Woodgate Nurseries and Adjacent Land
Proposal for up to 130 residential dwellings

Technical Note in Response to Network Rail Comments

(2401/TN/08)

January 2025

Figure 2.1 – Annotated extract of drawing HTP/2401/09/A

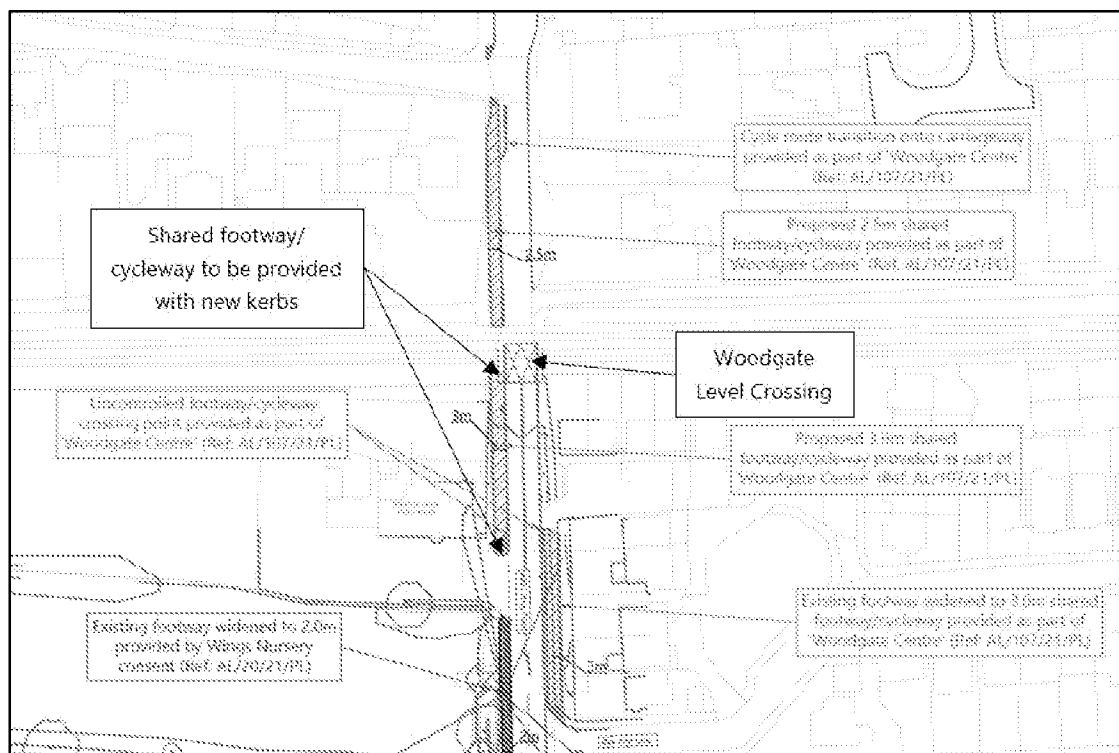
We acknowledge the comments from WSCC however we still have concerns over the safety of pedestrians using the crossing to access facilities to the north of the railway. This still requires pedestrians to cross without an alternative means to provide a safer route to cross

Of particular concern is pedestrians using the level crossing to access the facilities to the north of the railway, including the primary school, local shops and other community facilities. The BEW allocation potentially created an opportunity to allow the level crossing to be closed however, in the absence of this, the existing barriers provide a high degree of protection for motorists to ensure they stop when a train is passing. However, the lack of protection or alternative means of crossing for pedestrians remains a significant concern for Network Rail.

Based on the current layout of the crossing, the most suitable mitigation for pedestrians would be the provision of a footbridge over the railway, thereby ensuring pedestrians have the choice not to interact directly with the crossing and provides a safe means of crossing. This would significantly improve the current safety concerns, albeit not entirely remove them.

2.15 The pedestrian and cycle connections on the A29 and within the vicinity of the site are shown on drawing HTP/2401/09/A, contained in **Appendix 3**, with an extract of the drawing showing the approved works at the level crossing shown in **Figure 2.1**. The cumulatively approved works are summarised below:

- i. A new section of footway on the eastern side of Lidsey Road south of the Willows Caravan Park access
- ii. Widening of existing footways to 2.0 metres
- iii. Upgrades of footways to shared use footway/cycleways, with associated widening and the inclusion of kerbs
- iv. New pedestrian and cycle crossing points

2.16 Given that the existing pedestrian infrastructure will be improved to provide wider footways/cycleways, and that the existing footways will be kerbed, it is considered that the approved works will provide an improvement to the existing infrastructure.
